**RE: Plaza Hacienda at Old Town Phase II
Grading and Drainage Plan
Stamp Date: 10/24/17
Hydrology File: J13D037**

Based upon the information provided in your submittal received 10/24/2017, the Grading Plan is approved for Building Permit.

Renée Christina Brissette, P.E. CFM
Senior Engineer, Hydrology
Planning Department

SHEET TITLE
PHASE II GRADING PLAN

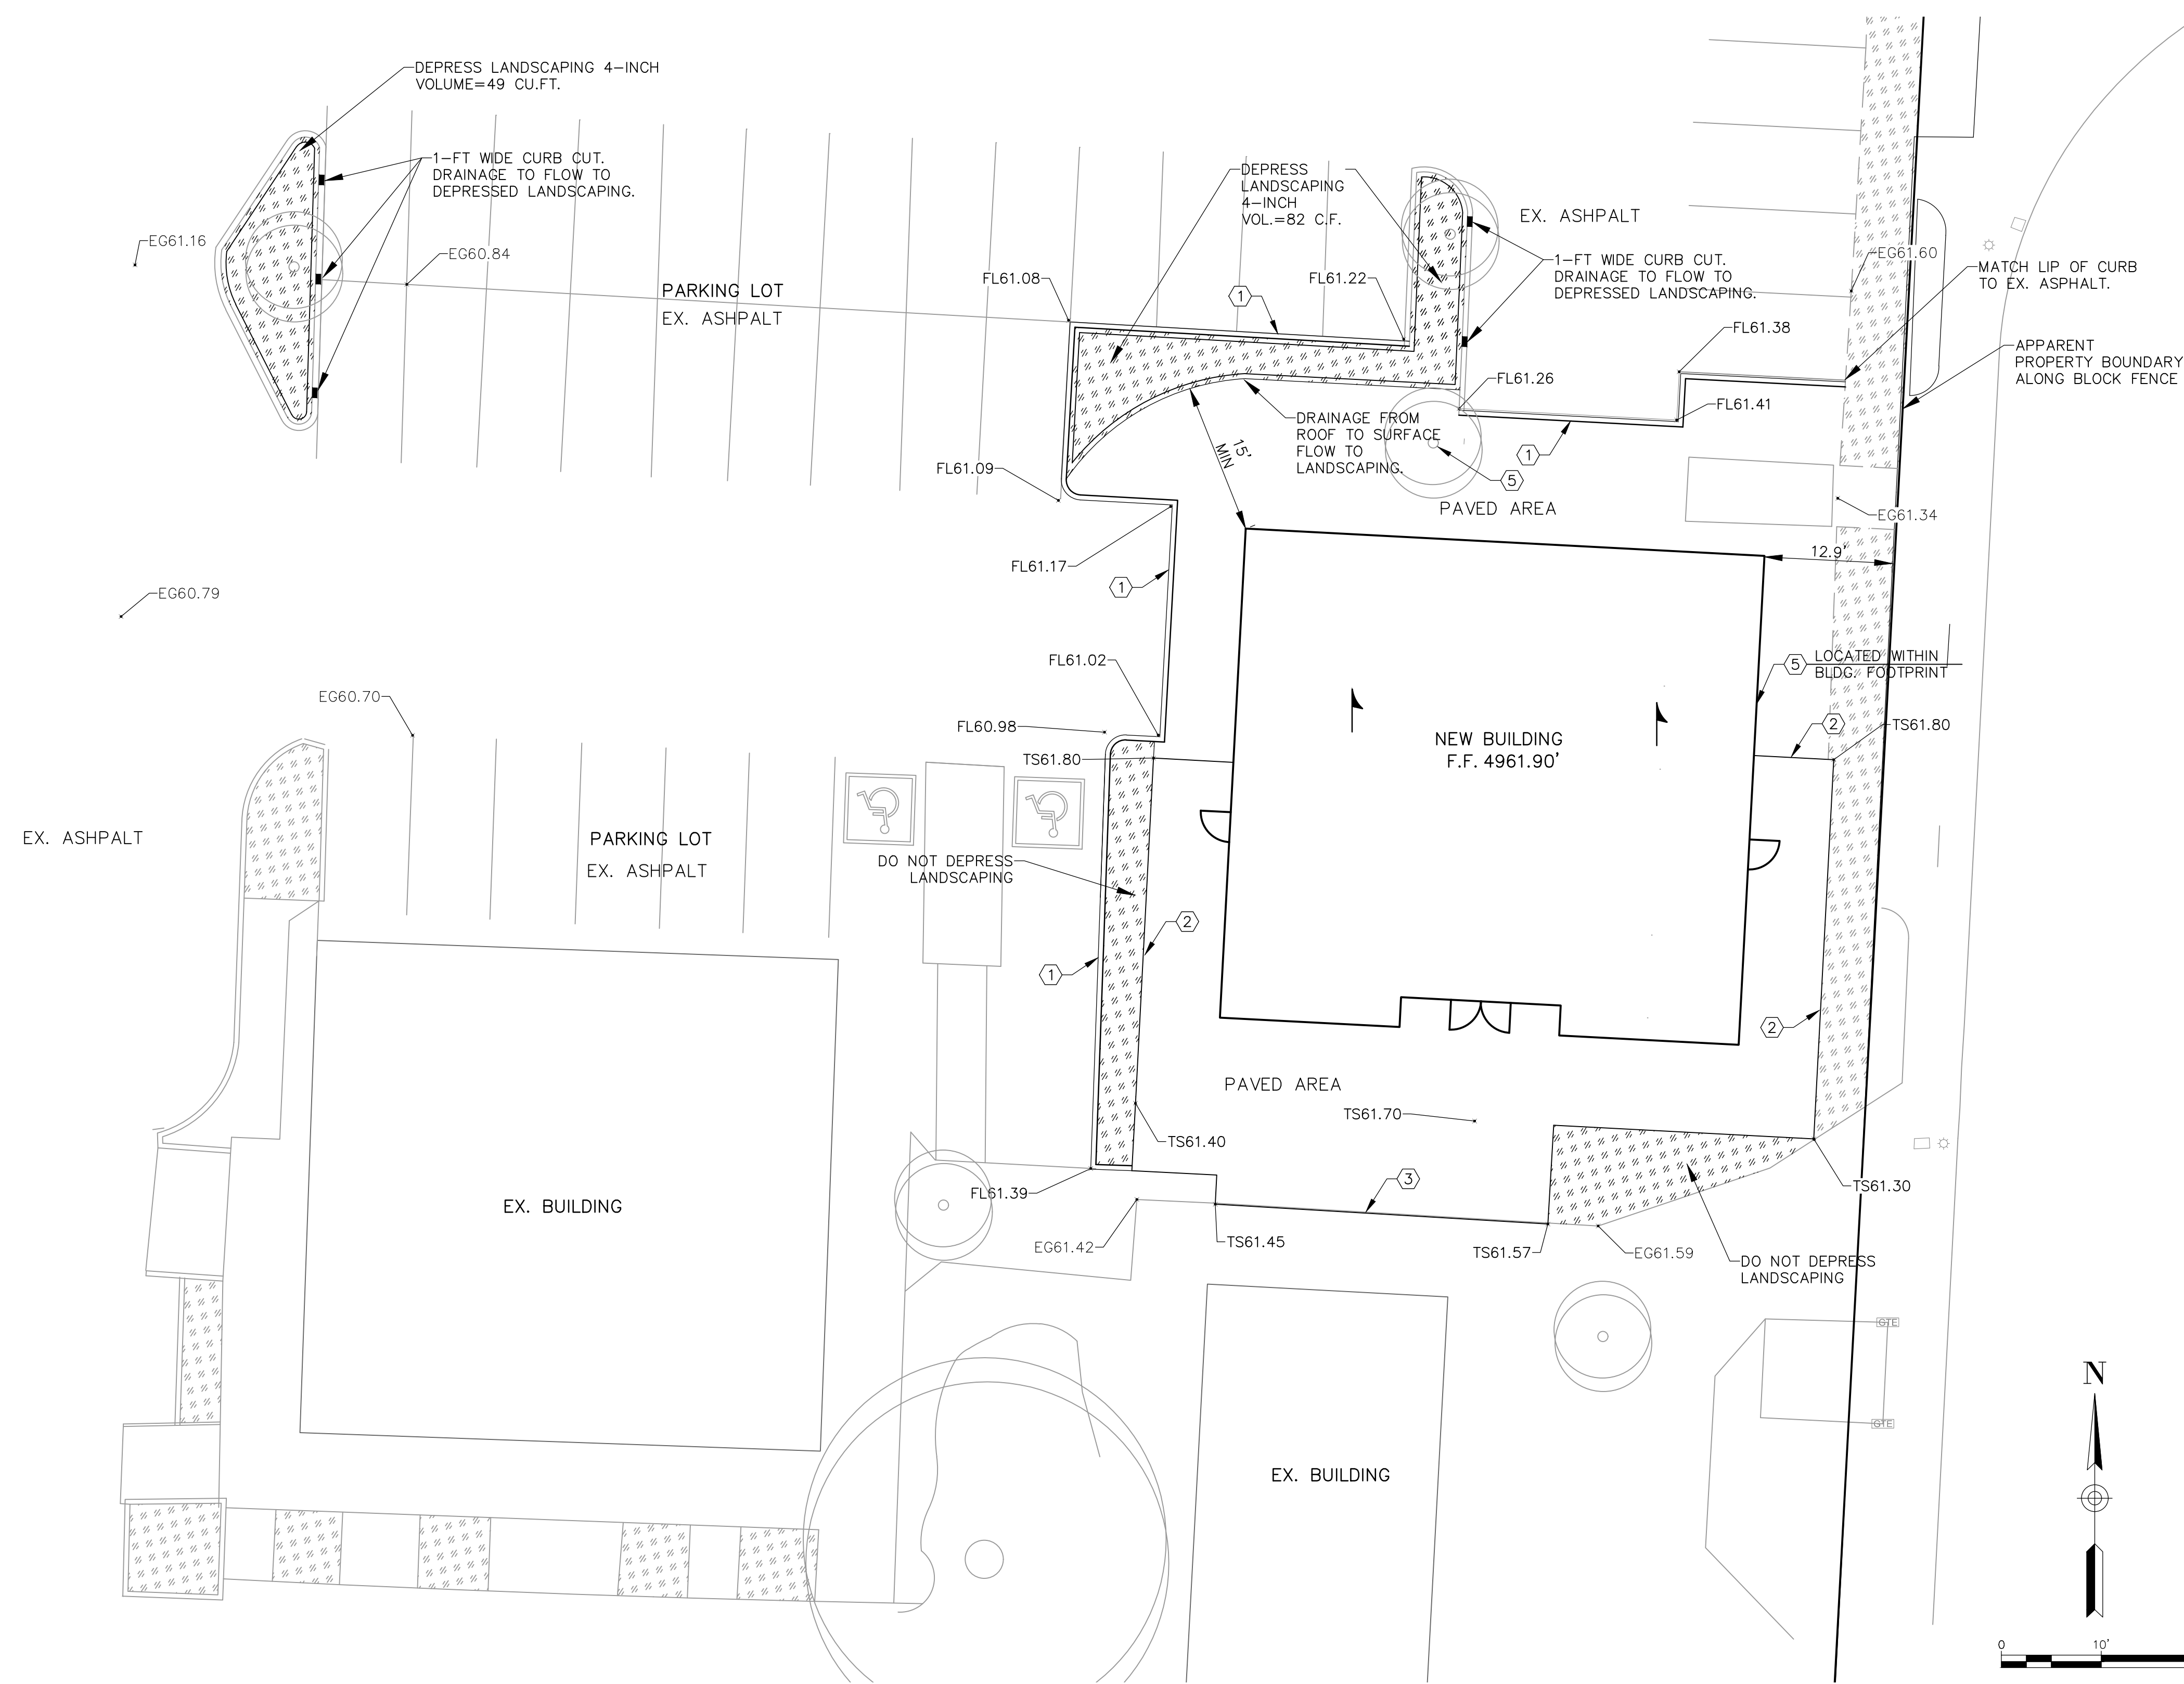
Please attach a copy of this approved plan in the construction sets for Building Permit processing. Prior to Certificate of Occupancy release, Engineer Certification per the DPM checklist will be required.
